TECHNICAL NOTE				VELOCITY4	
Client	Kitewood Estates Ltd.			Page No.	1 of 19
Project	Site A Willow Way, Sydenham			Project No.	22/089
Subject	Technical Note in Support of Planning Appeal			Document No	TN004
Prepared By	PM/AM	Checked and Authorised By	MK	Date	11 May 2023

**Table 1-1: LBL Officer Report Comments on the Application and VTP Response**

**Table 1-2: LBL Transport Comments on the Application and VTP Response**

SWEPT PATH ANALYSIS OF LARGE CAR ACCESSING ON-SITE PARKING BAYS

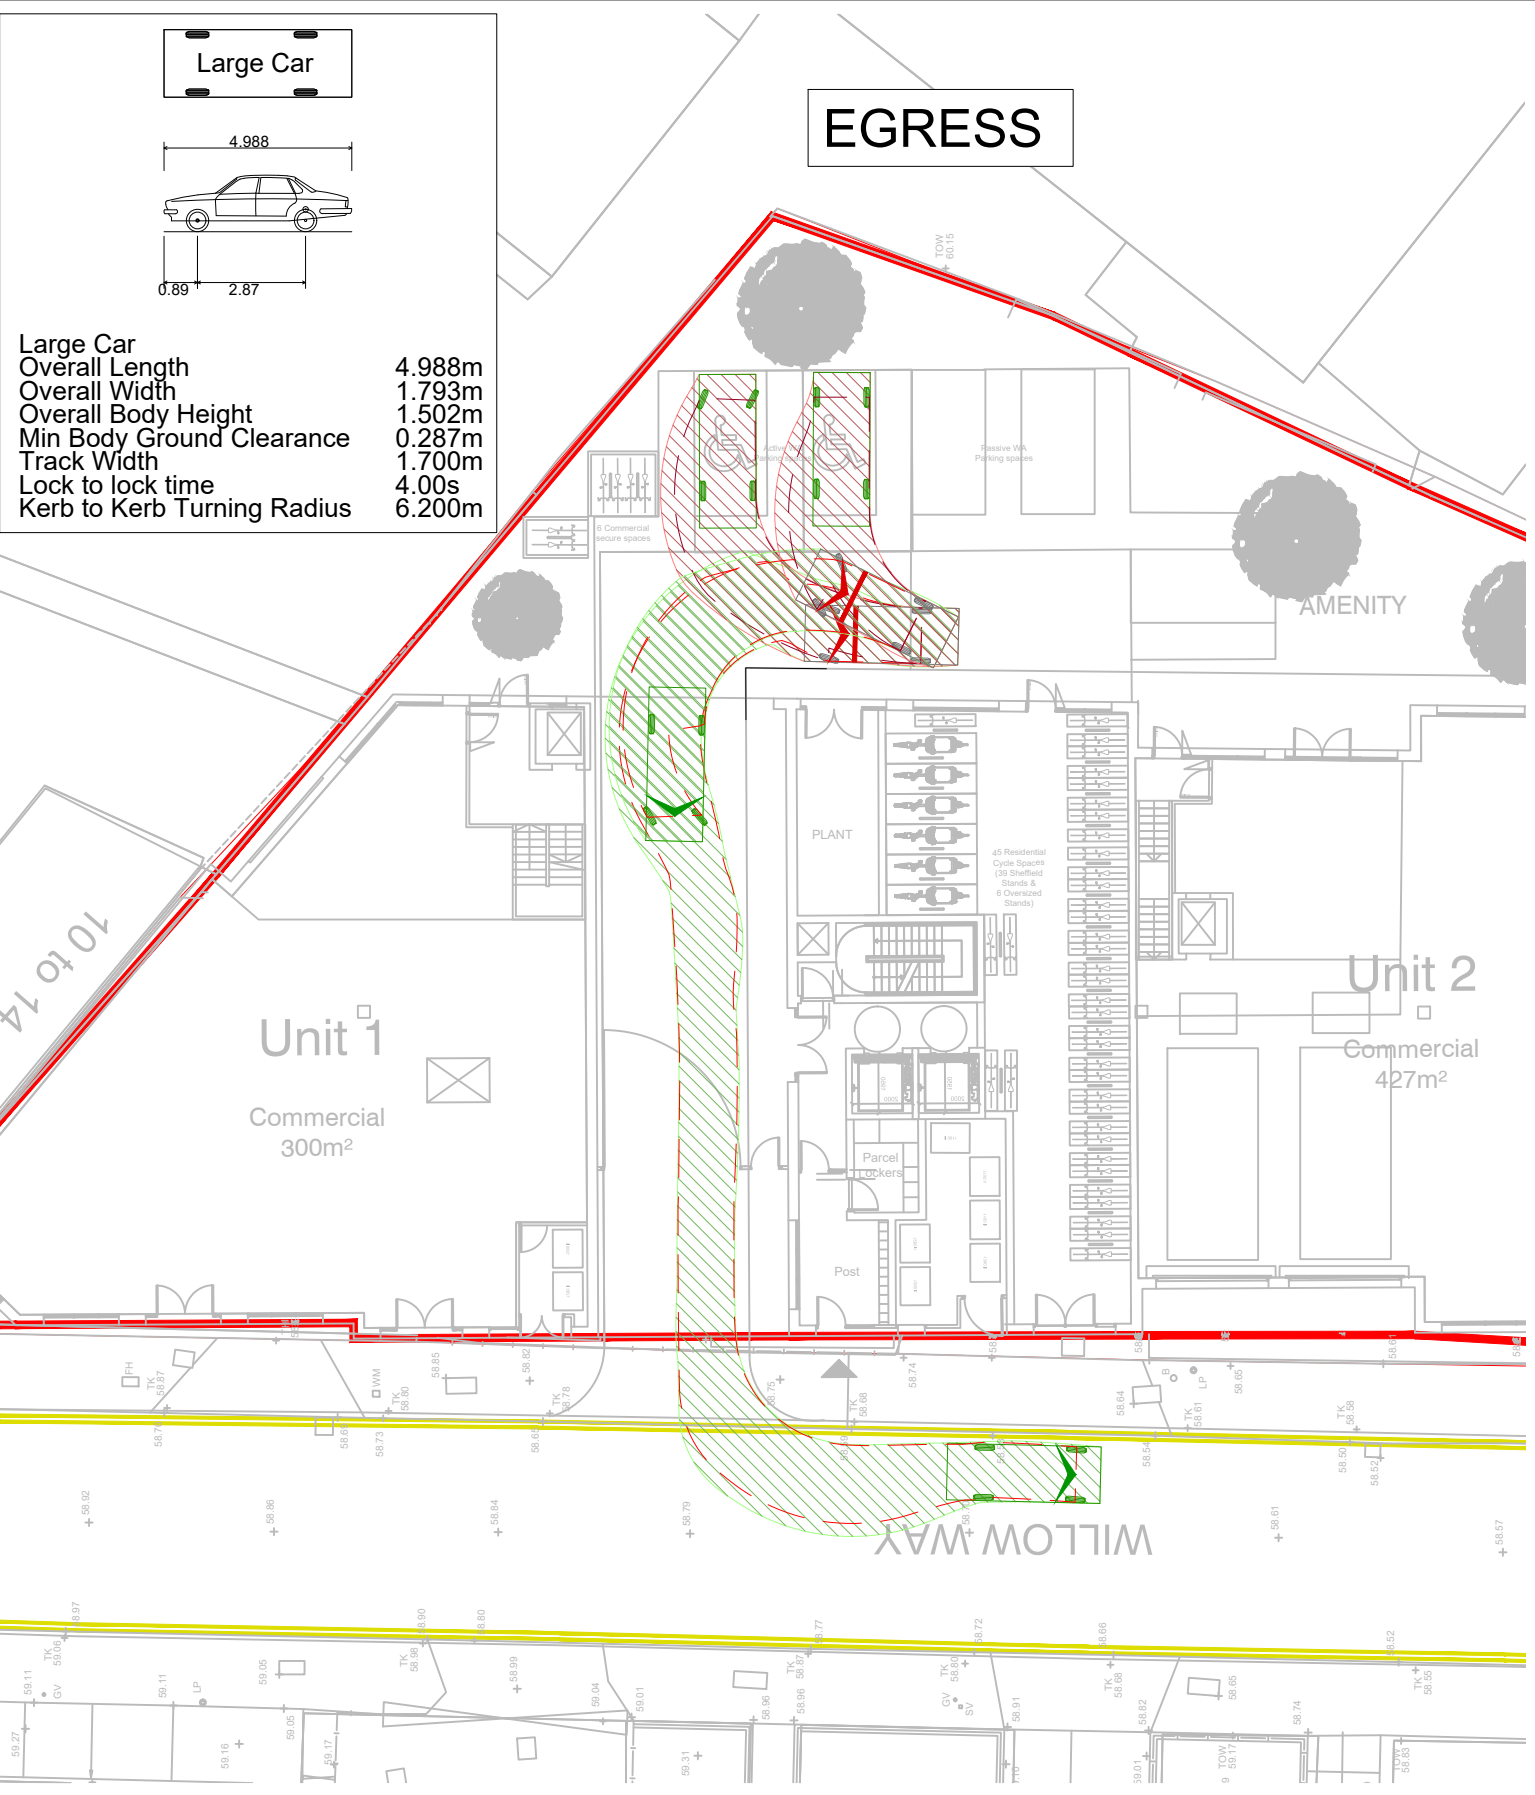
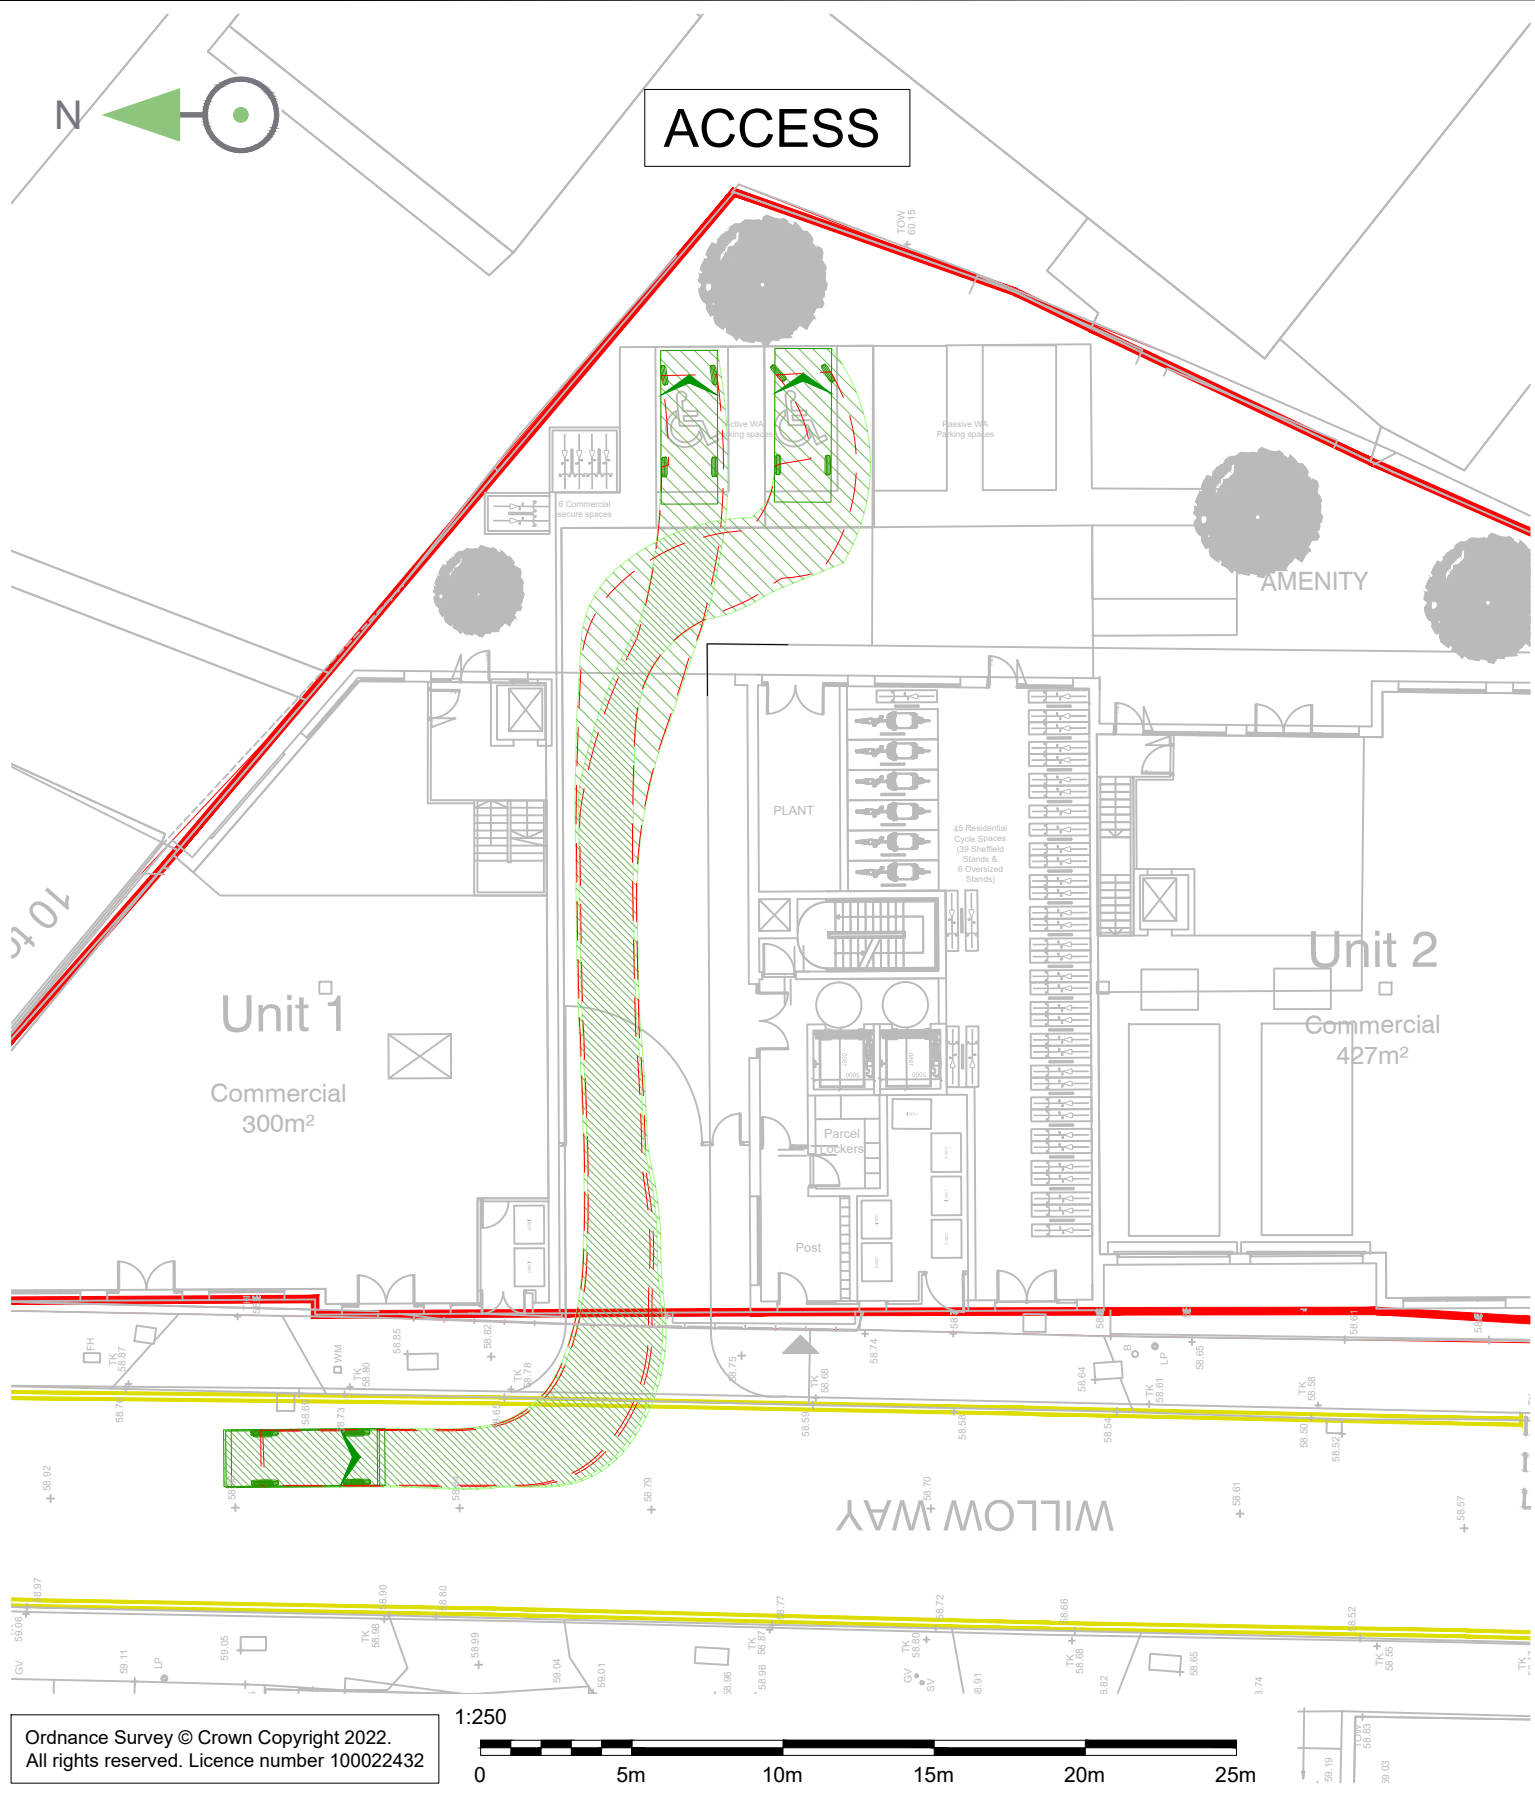
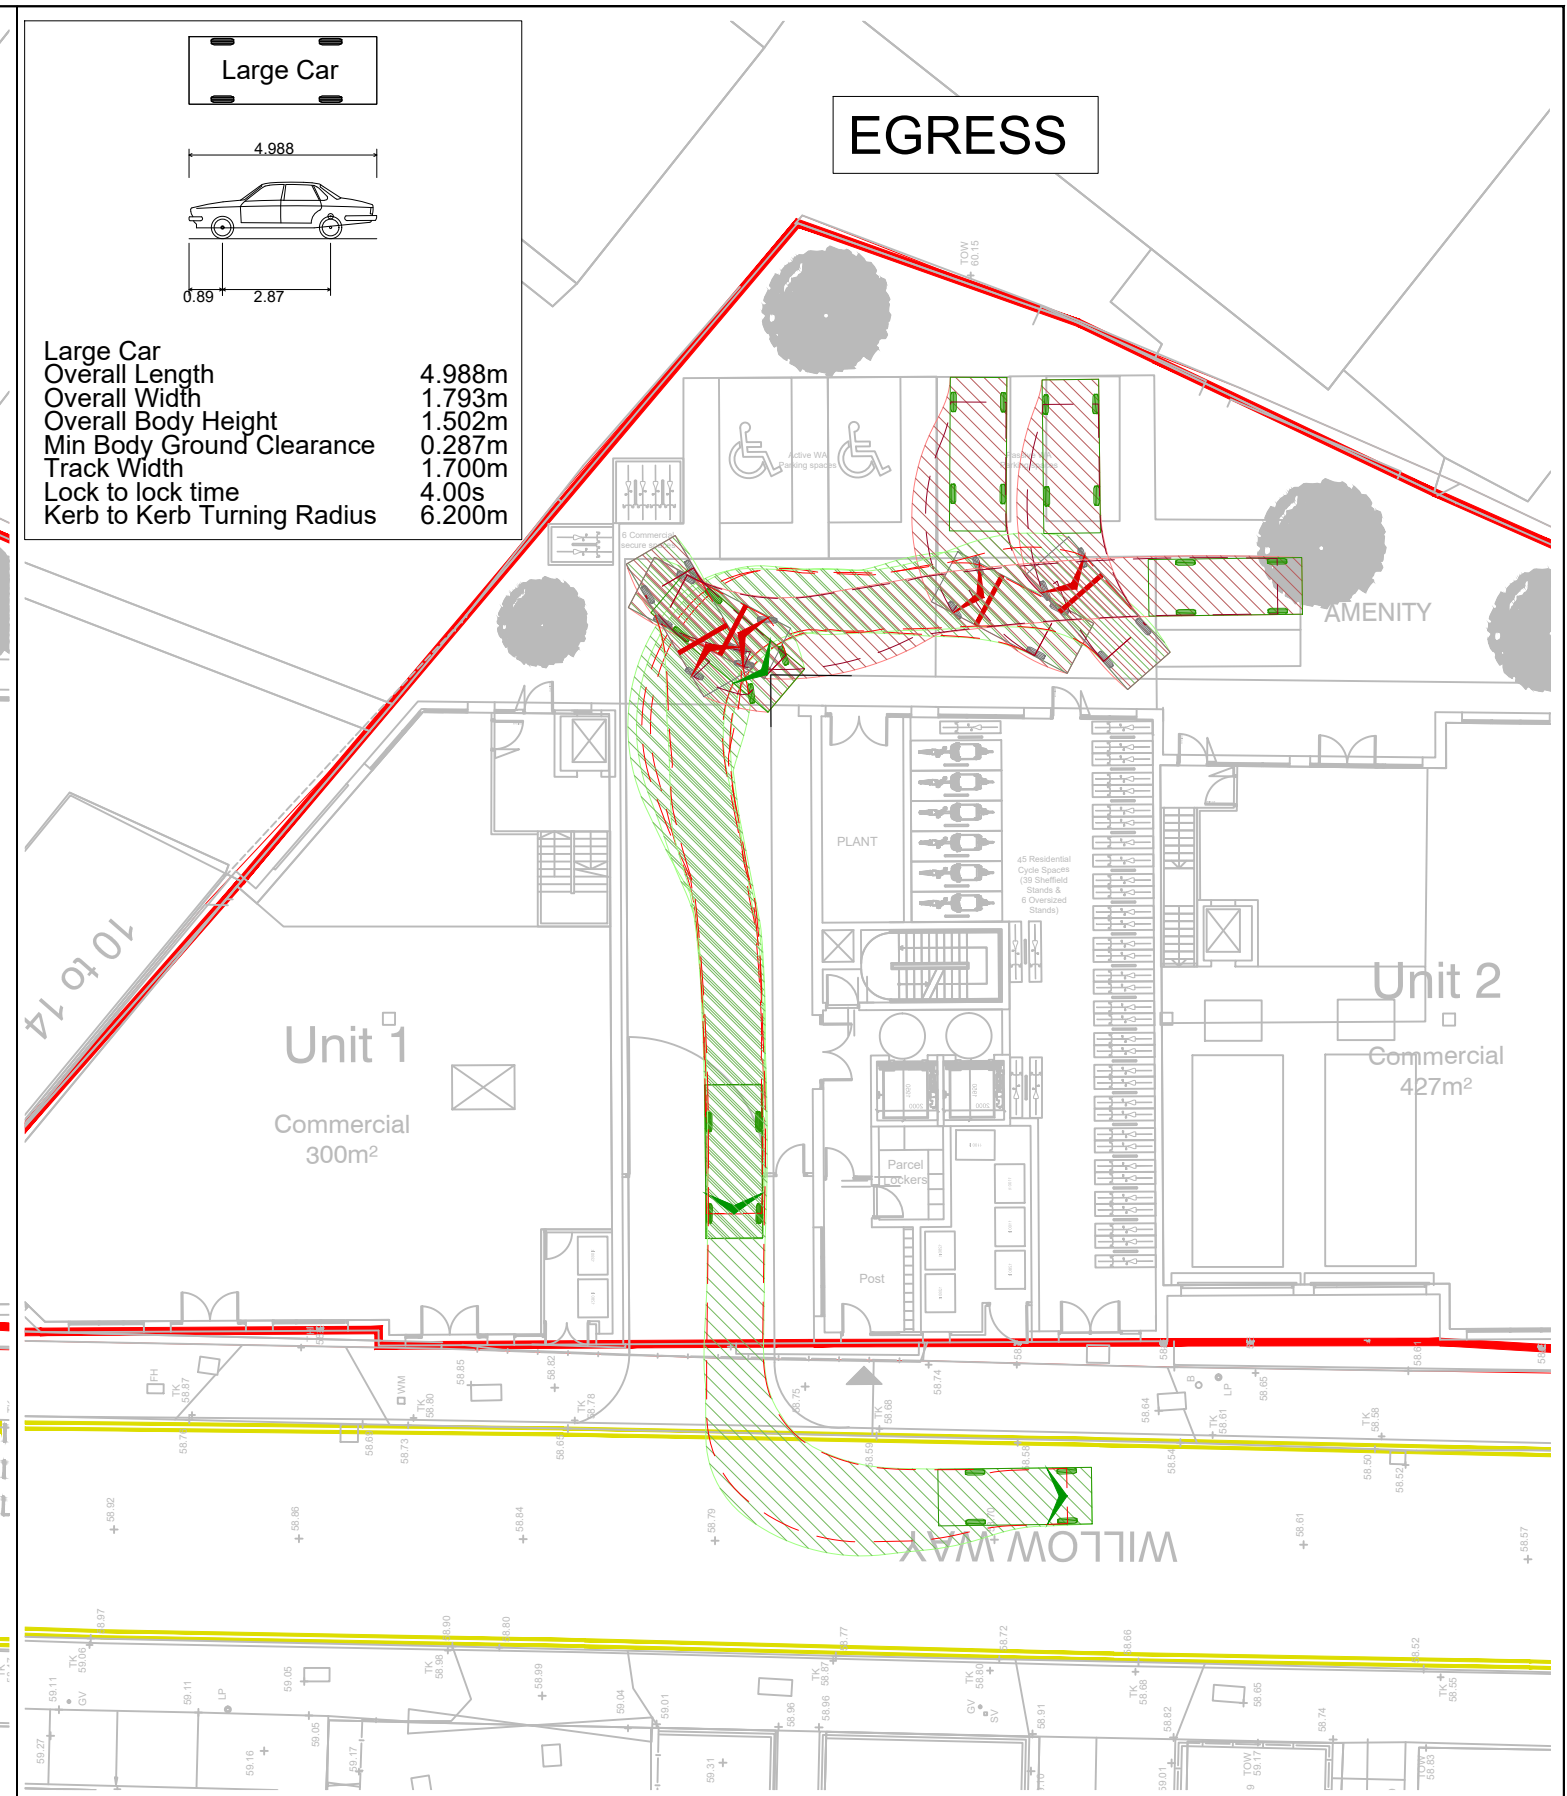
324	<p><b><u>Disabled Parking Spaces:</u></b></p> <p>The application omits one disabled parking space associated with the commercial proposals for staff or visitors. Policy T6.5 non-residential disabled parking stipulates access to at least one disabled parking bay (on or off street). This will need to be addressed.</p> <p>The application should also be accompanied with swept paths of a large vehicle accessing parking and egressing the site which has not been provided.</p>	<p>It is accepted that a specific disabled parking space for the commercial element has been omitted as part of the application. Given the proposals include safeguarded space on-site to accommodate an extra 3 disabled parking spaces, it is considered that one of these spaces could be allocated to the commercial element in the first instance.</p> <p>An additional on-street space could be provided (within the public highway, and therefore outside of the application boundary) in order to maintain the safeguarded provision for 10% of the residential units to have a disabled parking space. This could be provided as part of the TRO process, should it be required.</p> <p>As the number of blue badge holders within Lewisham's population is around 2% (DfT Statistics, Table DIS0109, 2016 data), it is considered highly unlikely that there will be demand by residents for use of all six disabled bays proposed in the application. Blue badge holders in Lewisham can also park on single or double yellow lines for up to three hours where loading/unloading is permitted (Section 4.3 of LBL Parking Policy, March 2023) meaning any demand by visitors can reasonably be accommodated on-street.</p>

PARAGRAPH	PLANNING OFFICER / LBL HIGHWAYS COMMENT	VTP RESPONSE
		<p>The revised approach is therefore considered to be acceptable within the constraints of the site.</p> <p>It is anticipated that access to the rear parking court will only be permitted to standard sized service vehicles in exceptional circumstances such as plant needing maintenance. The rear parking court was therefore designed primarily to accommodate movements of cars.</p> <p>Swept path analysis shown in <b>APPENDIX F</b> demonstrates that large cars can access and egress all parking spaces adequately.</p>
325	<p><b>Electric Vehicle Charging Infrastructure:</b> 20% of the disabled bays should be EV ready with 20% passive provision. This equates to one disabled space with an EV charging point and one passive space. This will need to be shown on the plans and secured by condition.</p>	<p>It is noted that the proposals set out within the application propose to exceed this provision by providing two active charging spaces from the outset. However, the Applicant will achieve this requirement in any case.</p>
